**DEVELOPMENT ASSESSMENT CASE NUMBER:** CD-2014-0005.SH

Presentation of a Development Assessment Report for the Colony Park Sustainable Community Initiative Planned Unit Development (PUD), located at Loyola Lane and Wentworth Drive, within the Walnut Creek, Elm Creek and Decker Creek watersheds.

Re: Colony Park Development Assessment  
CD-2014-0005.SH  
Response Comments

DEVELOPMENT  
ASSESSMENT  
LAND PLAN

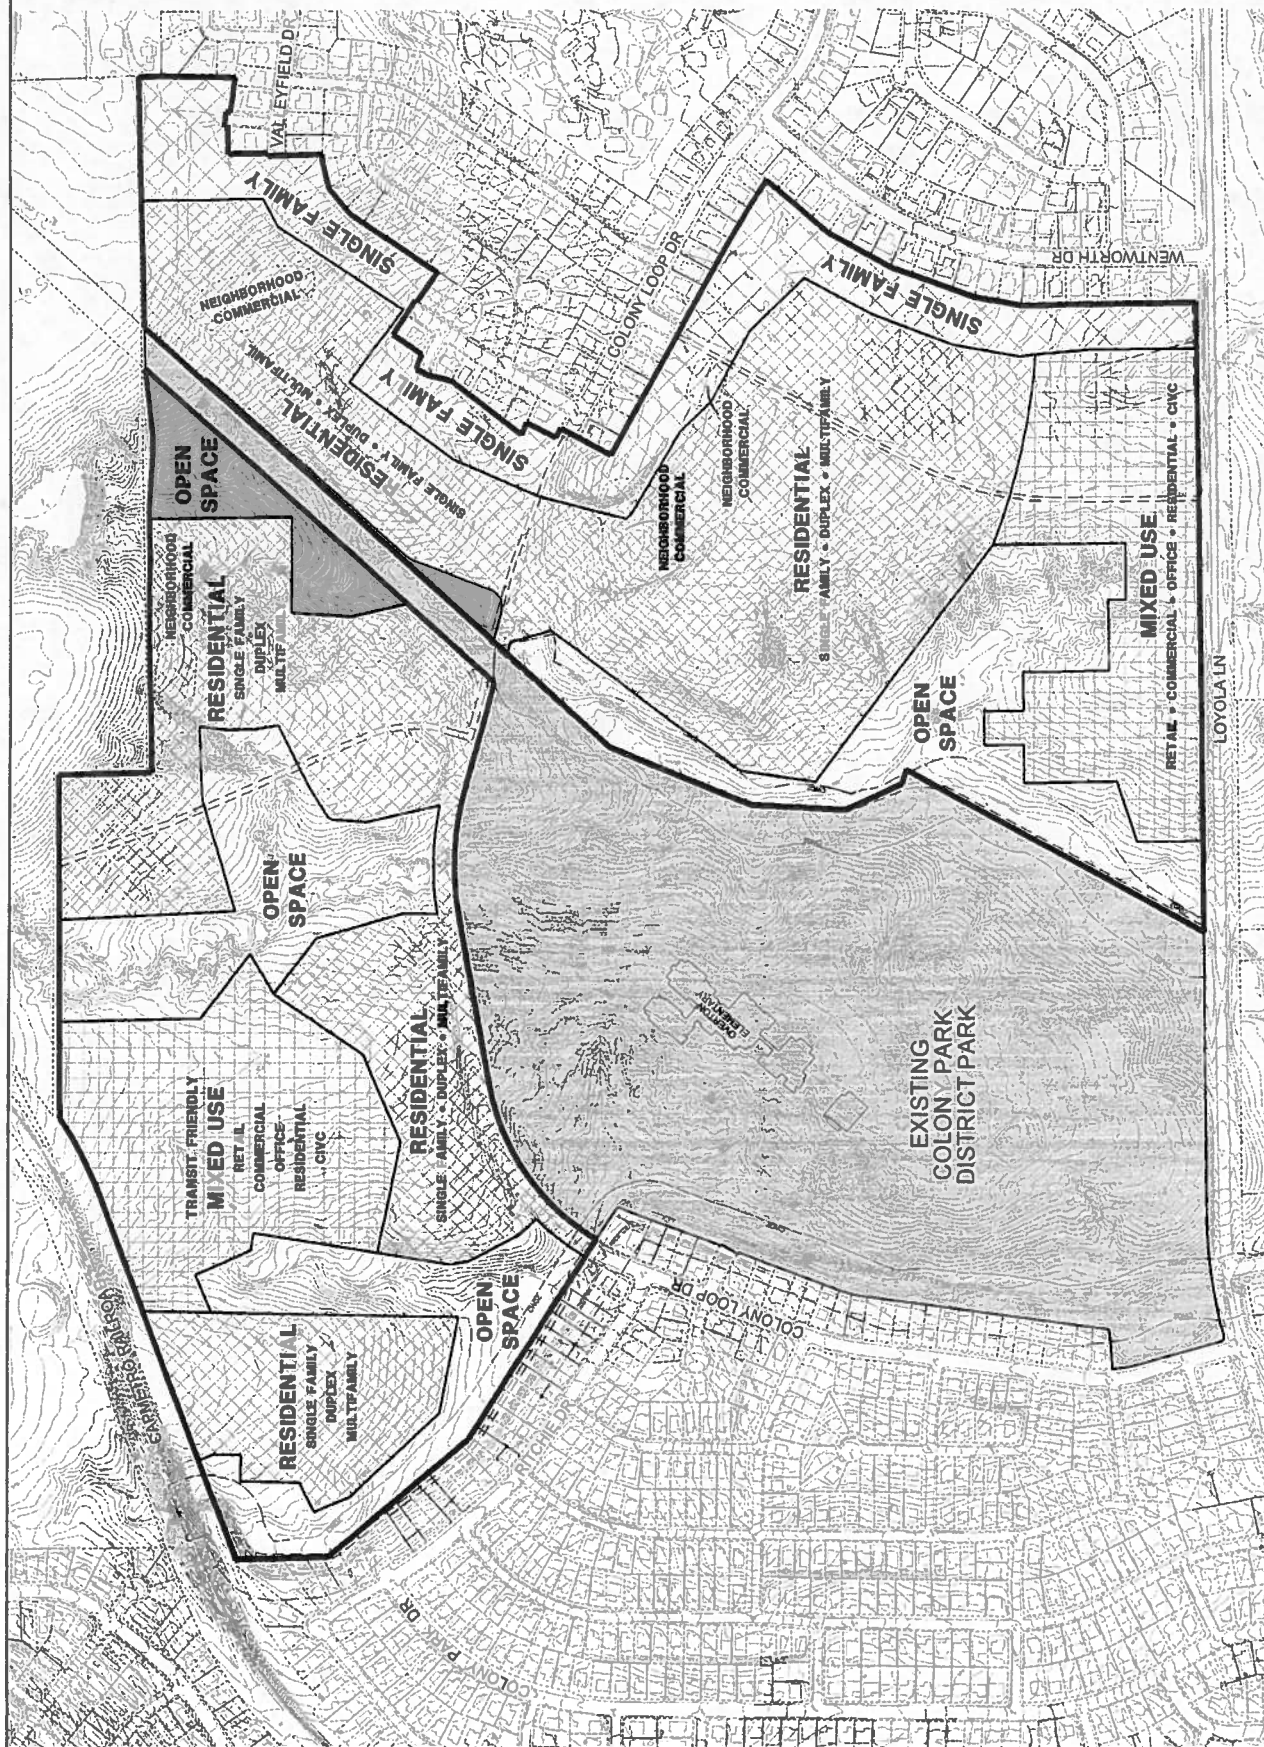
- ZN 1. Add the following information to the Land Use Plan: existing land uses, existing zoning (onsite and adjacent). Zoning and land use should be shown for surrounding properties within 200 feet of project.

- ZN 2. Show and label clearly the existing and proposed streets and/or roadways. For example, clearly label where existing Colony Loop Drive ends, and proposed extension begins, as well as right-of-way (ROW) widths. If street names have not yet been assigned, use something like "Street A, Street B," etc.

ZN 7. Add page numbering (1 of 1, etc.) to each sheet. Provide a site location map (minimum 5" x 5") that clearly shows the PUD project location in relation to city, major roadways. Recommendation: remove hatching from Land Use Areas so topographic information will be easier to read.

ZN 8. Clearly show and label all easements on the property, including recording information.

**UDG RESPONSE: The existing and surrounding zoning and land uses of SF-2, SF-3, MF-2, and the surrounding zoning and land uses will be added to the PUD application.**

**UDG RESPONSE: Street names or designations and ROW widths will be added to PUD.**

**UDG RESPONSE: This will be done.**

**UDG RESPONSE: This will be done.**
